Independent Review of Flood Modelling Undertaken for the Macintyre River Floodplain

Inland Rail Project - Border to Gowrie (B2G)

Goondiwindi Regional Council
1283-02-E, 29 April 2021

Figure 4-4 - Locations of adopted hydraulic model inflow boundaries, calibration events

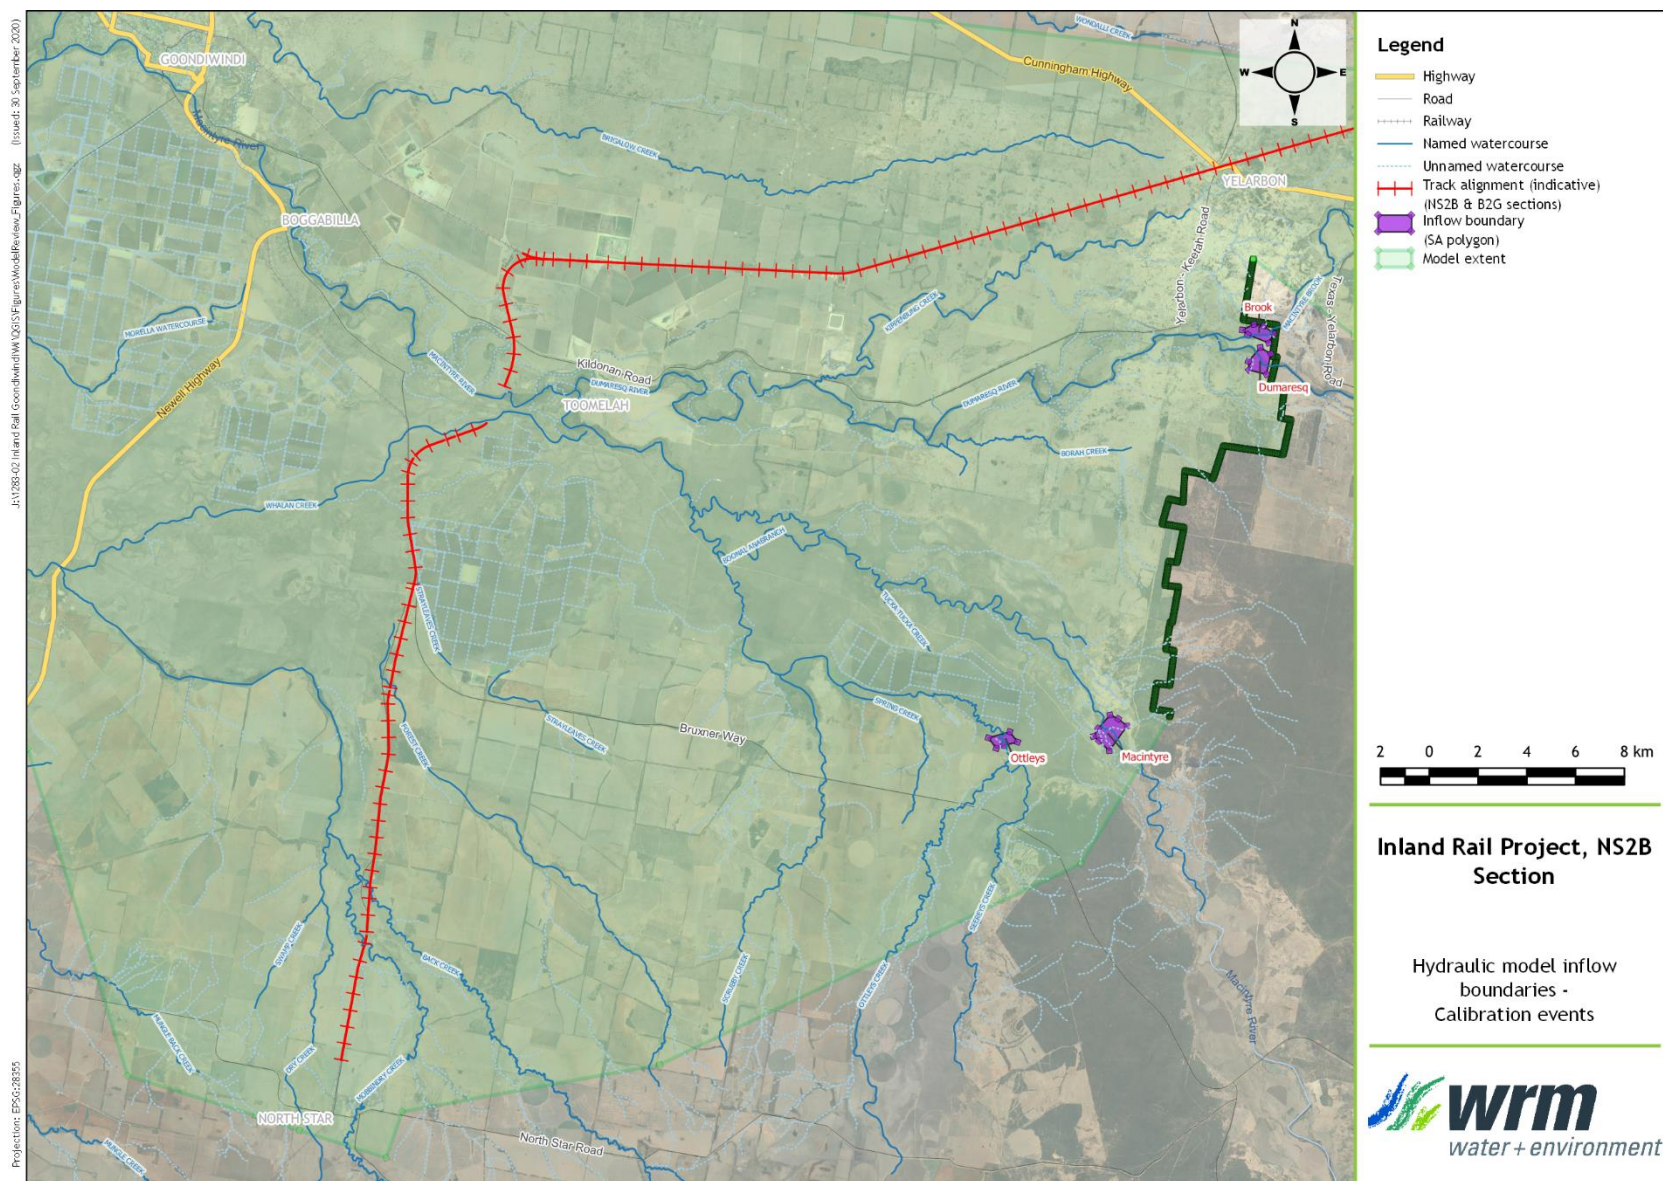
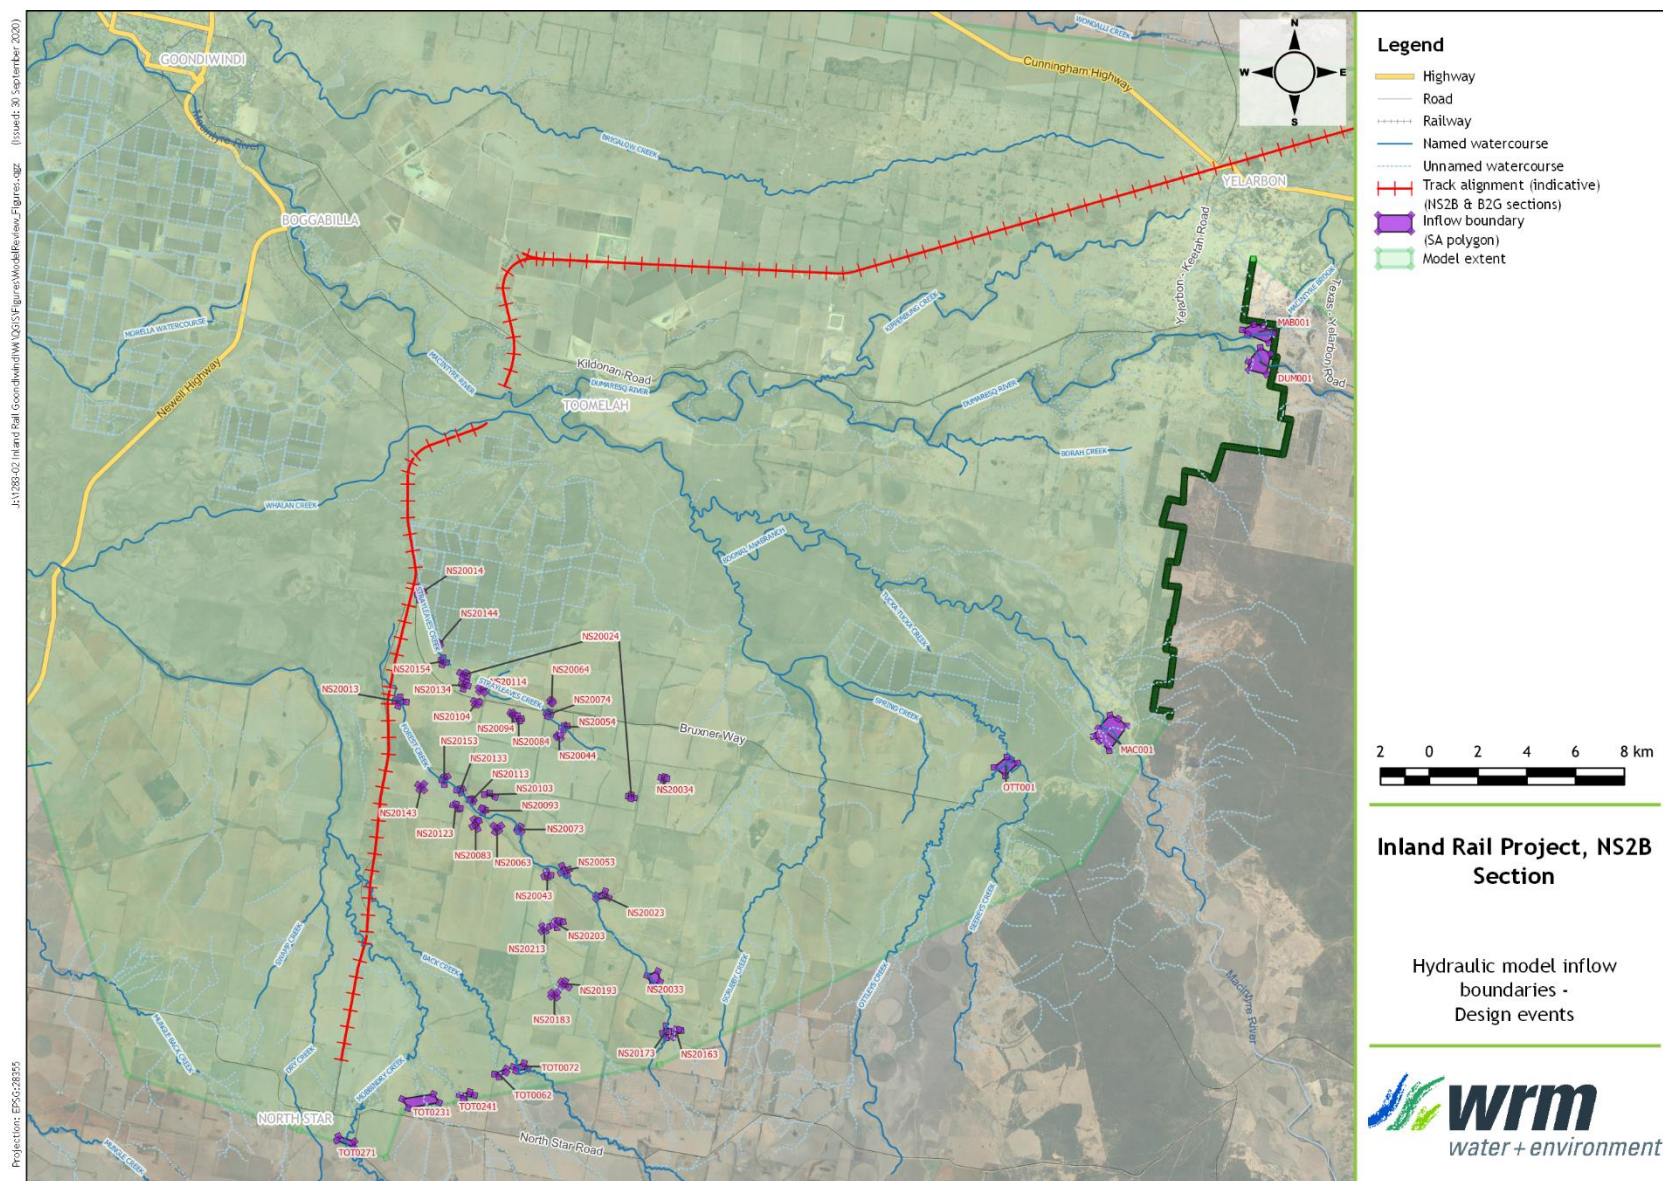
Figure 4-4 and Figure 4-5 show the locations (i.e. placements) of inflow boundary conditions in the hydraulic model for calibration events and design events respectively. The placement of model inflow boundaries raises a number of significant issues with respect to accuracy and reliability of model results, including:

Figure 4-6 - Approximate locations where hydraulic structures may not be adequately represented in the TUFLOW model

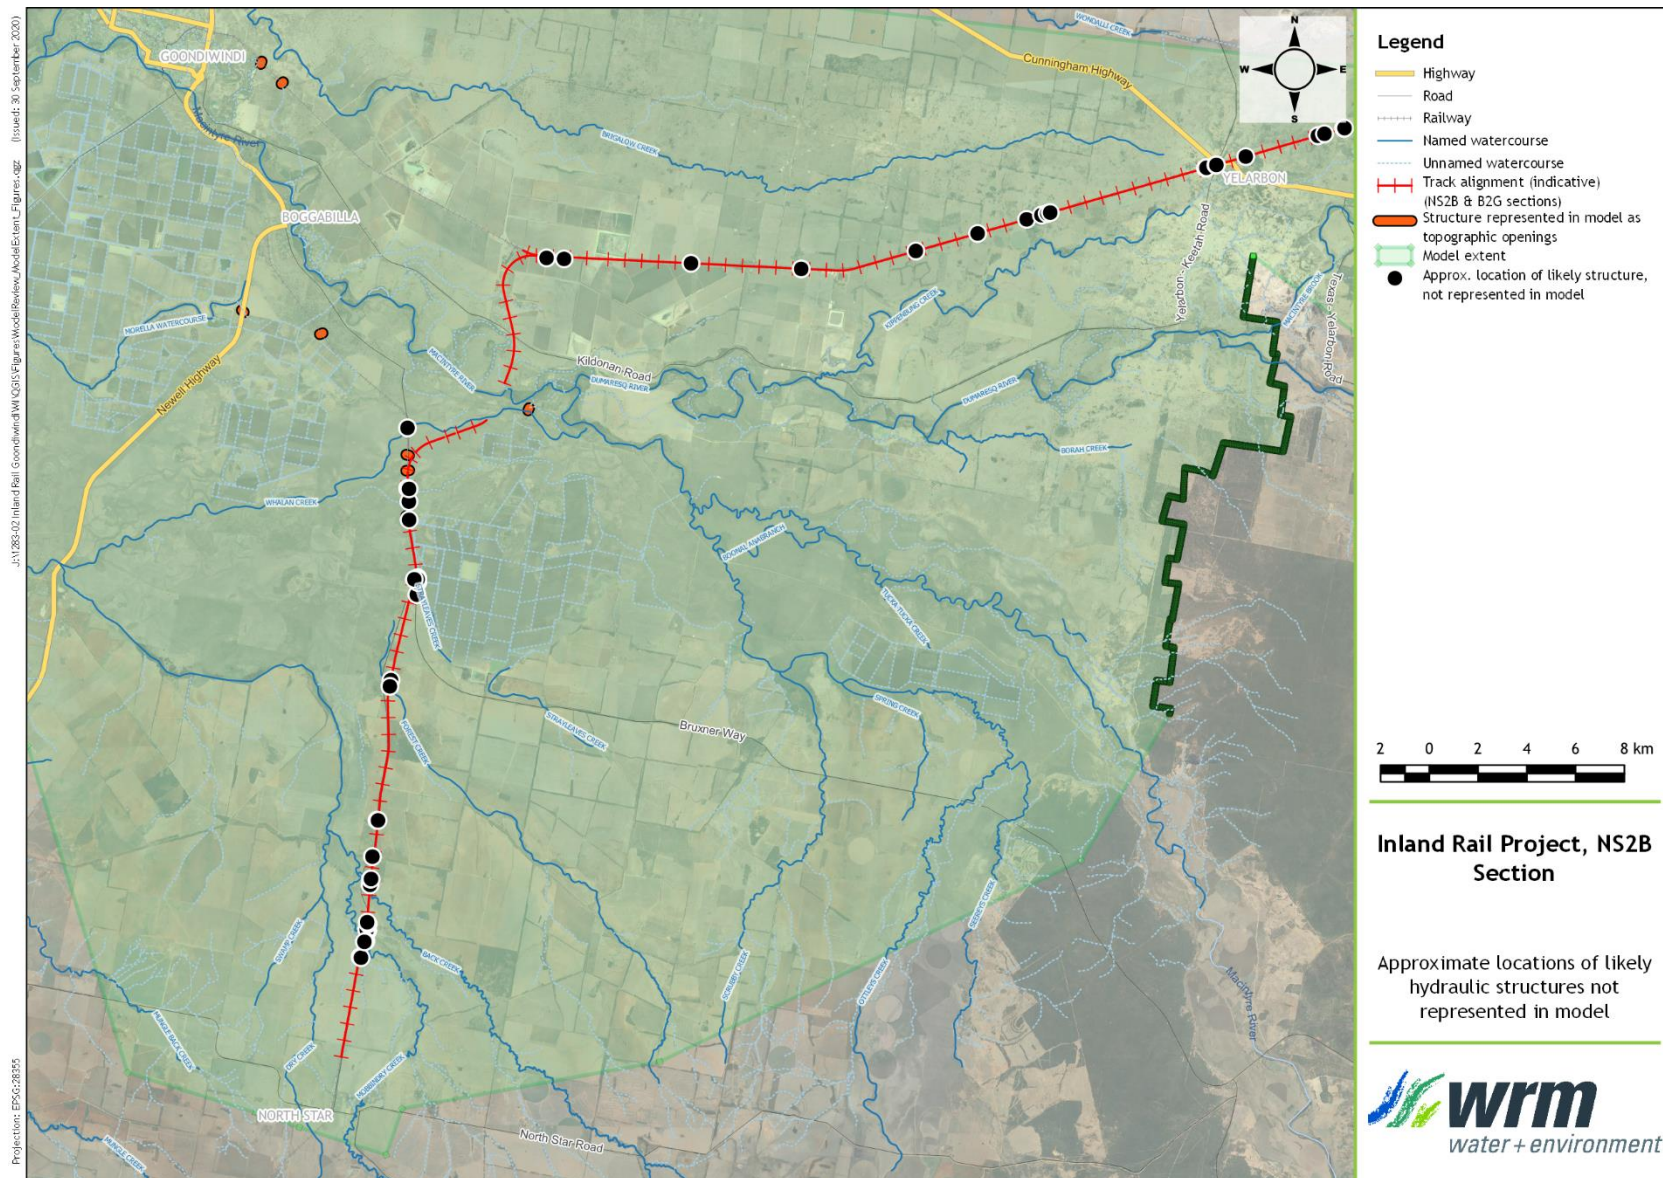
There appears to be a number of cross drainage structures along the existing rail and road alignments which are not represented in the hydraulic model under existing conditions (e.g. road cross drainage and bridge structures) because the LiDAR appears to be read in **'as-is', without adequate openings or** other modifications. However, these structures are being represented under developed conditions (e.g. Mobbindry Creek, Back Creek) with designed hydraulic structures. Some of the approximate locations where existing hydraulic structures may not be adequately represented are shown in Figure 4-6.

Figure 6-1 - Comparison of GEV and LPIII flood frequency distributions for Ottleys Creek at Coolatai (source: BOM Water Data Online)

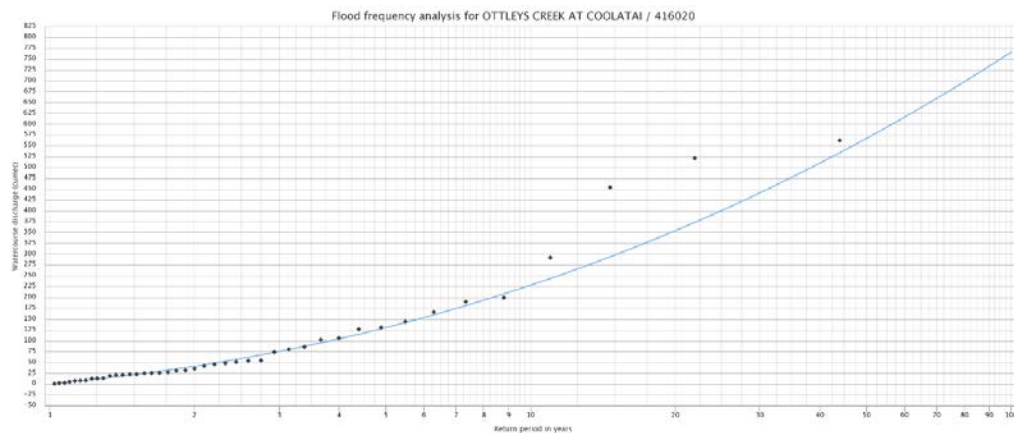
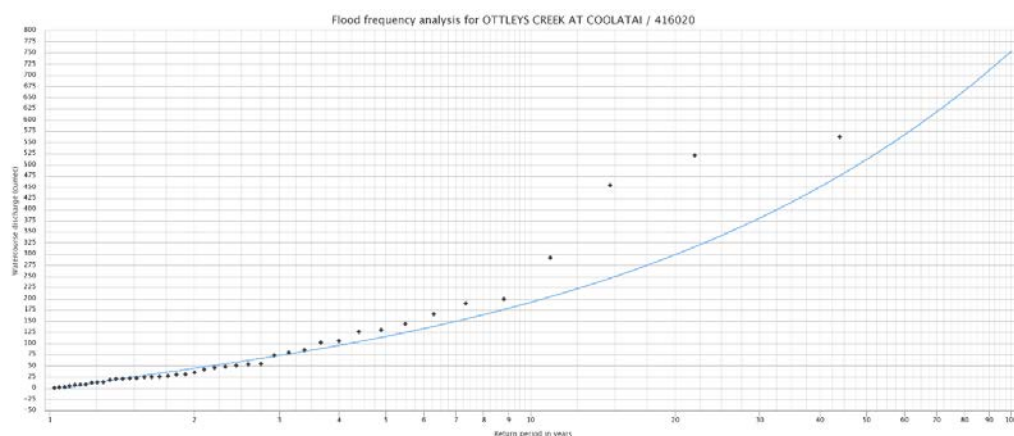
- The GEV and LPIII distributions provide similar results only for Ottleys Creek at Coolatai (see Figure 6-1);
- For the Macintyre River at Holdfast, the LPIII discharges are about 21% and 15% respectively higher than the GEV discharges for the 2% and 1% AEP events (see Figure 6-2);
- For the Dumaresq River at Roseneath, the LPIII discharges are about 22% and 23% respectively higher than the GEV discharges for the 2% and 1% AEP events (see Figure 6-3); and
- For the Macintyre Book at Booba Sands, the LPIII discharges are about 16% and 5% respectively higher than the GEV discharges for the 2% and 1% AEP events (see Figure 6-4);

Figure 6-4 - Comparison of GEV and LPIII flood frequency distributions for Macintyre Brook at Booba Sands (source: BOM Water Data Online)

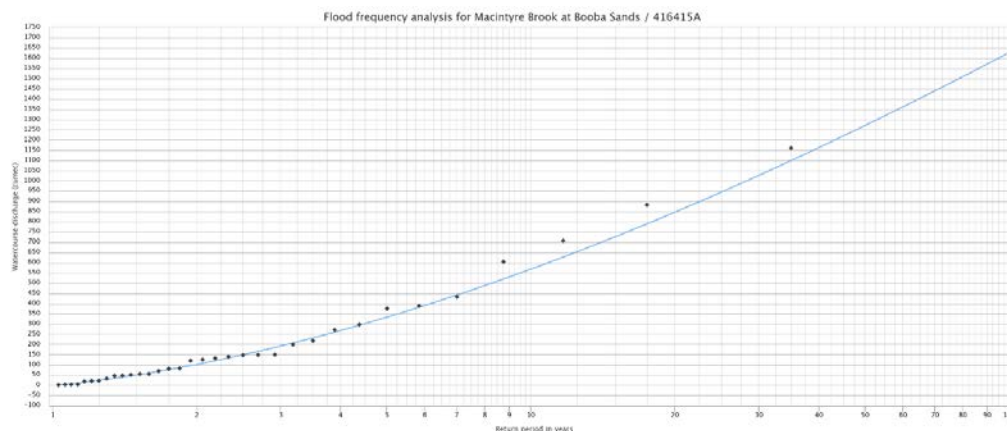
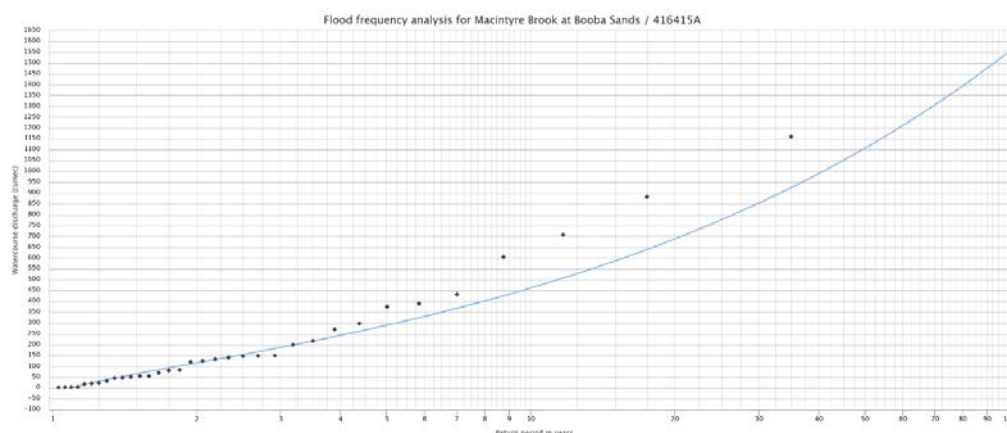
- The plotted modelled design 1% AEP discharge for Macintyre Brook at Booba Sands does not appear to be correct. The plotted value in Appendix H (Figure 8.1) is about 1,100 m³/s whereas the URBS model predicted value is 2,278 m³/s.
- The plotted 1996 flood discharge in Appendix H (Figure 8.5) for the Ottleys Creek at Coolatai should be larger than a 2% AEP after the required correction for the incorrectly plotted recorded discharges in Appendix H (Figure 7.6).

Figure 7-1 - Adopted local inflows along Strayleaves Creek, 1% AEP, 12 hours design event

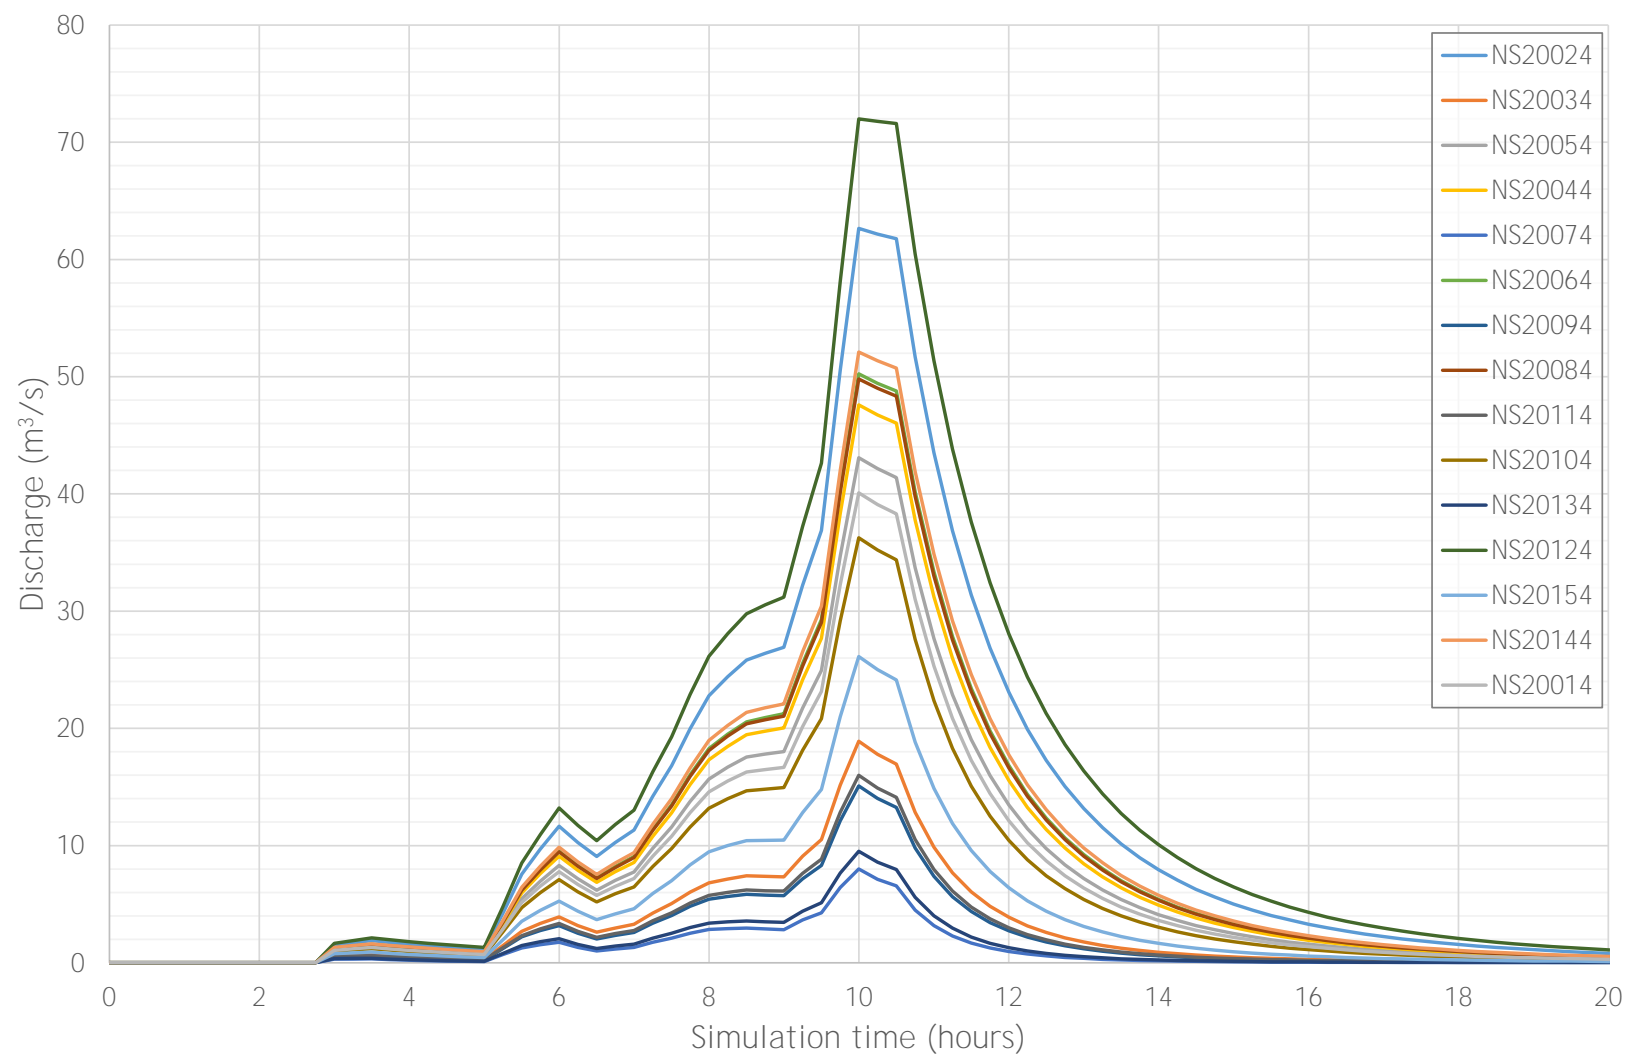
For Forest Creek and Strayleaves Creek, all adopted local inflows appear to be a scaled version of each other, with the same hydrograph shape and timing at all inflow locations along these creeks as shown in Figure 7-1. It also appears that the same inflow has been incorrectly allocated to two locations (labelled NS20024) along Strayleaves Creek as shown in Figure 4-5.

be similar and be proportional to the sub-catchment area. They have also noted that the local inflows applied to the hydraulic model only have a small degree of routing through the URBS model. I note that, based on the adopted subcatchment inflow hydrographs shown in Figure 7-1, no subcatchment routing is apparent.
